Design Review Board Staff Report

SUBJECT: DR14-16, HAMPTON INN & SUITES, LOCATED AT THE
SOUTHEAST CORNER OF HIGLEY ROAD AND INVERNESS
AVENUE.

DR14-16: Hampton Inn & Suites: final site plan, landscape, grading and drainage, elevations, floor plans, lighting, colors and materials for Hampton Inn & Suites and preliminary site plan for a future retail/ office pad, on 4.8 acres located at the southeast corner of Higley Road and Inverness Avenue and zoned Regional Commercial (RC) zoning district.

**BUILDING ELEVATIONS
NORTH & SOUTH SIDES**

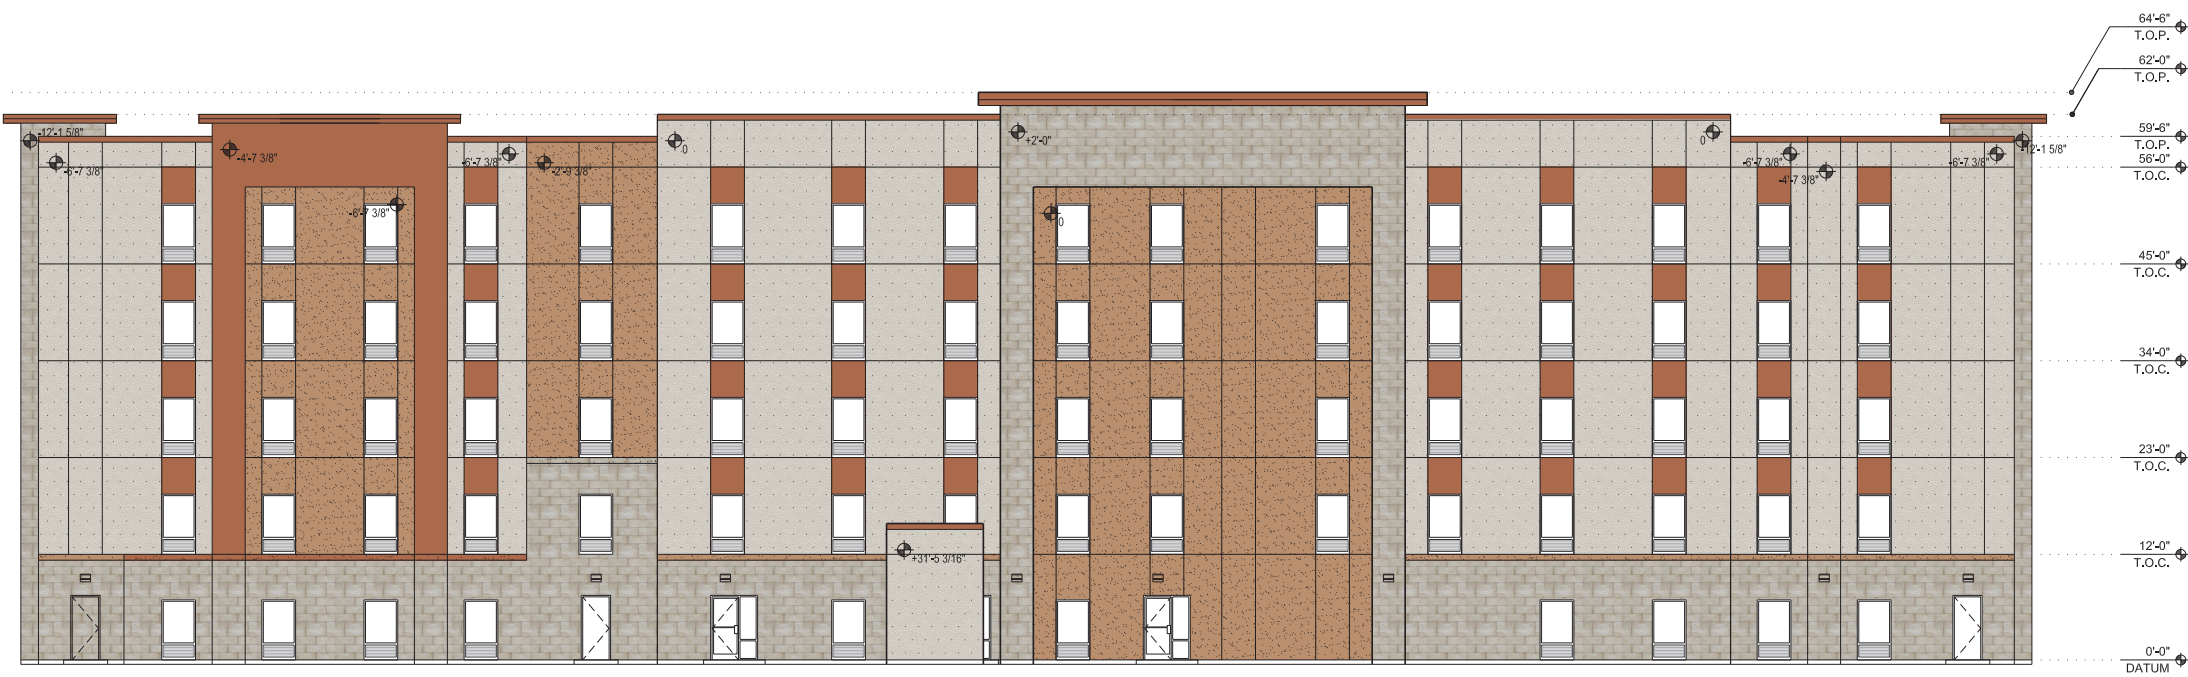
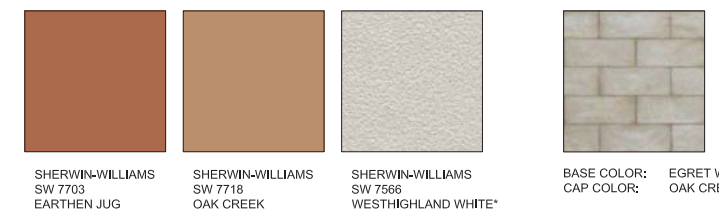
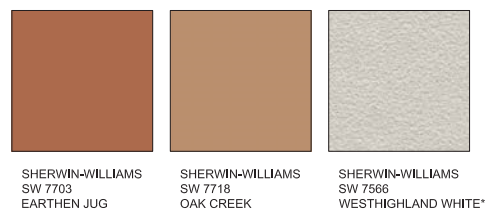
1. Concerned with scale of the building and if the Commercial Design Guidelines are being used - mass and design is lacking, not enough horizontal, windows are flat –

2. Verticality needs to be broken-up, stone doesn't need to go up to the roof line, maybe introduce a third option--maybe a color, it needs a distinctive quality, maybe play on the windows, another shape? it looks prominently vertical –

3. The photo of the built example shows sills and caps around the windows, the stone on the proposal doesn't have any definition, windows need to have some depth –

4. The elevations do not appear to meet the commercial design guidelines, the window sizes on the photo, the proposed windows look taller and thinner, massing both horizontal and vertical are not there. There is a need to have this hotel be in the same caliber as the other approved hotels.

- a. *The applicant notes that the elevations have been redesigned based upon DRB and staff review comments, utilizing examples from the Banner Gateway Medical Center and Marriot Residence Inn across Higley Road. A third color of EIFS has been incorporated to improve the emphasis between massing elements and the stacked stone veneer revised to a more modern Alabaster veneer with more horizontal and pedestrian scale massing to break up the verticality of the 5-story building.*

- a. *The applicant has incorporated a new stone veneer revised to a more modern Alabaster veneer with more horizontal and pedestrian scale massing to break up the verticality of the 5-story building. The taller parapet caps have also been accentuated horizontally.*

- a. *The applicant notes that redesign is inspired by contextual building examples and window conditions with a third color choice now provided. The new Alabaster veneer is utilized to relate to contextual aesthetics and the material palette of surrounding prominent buildings.*

- a. *The applicant notes that the building elevations have been redesigned to appear more cohesive with its surroundings. Horizontal elements (Alabaster veneer, veneer cap, top of parapet wall caps) have been incorporated to balance between horizontal and vertical, while the overall palette is influenced by contextual examples. The redesign of the elevations is focused on massing, color and texture changes, parapet accents, providing for more pedestrian scale and window treatments.*
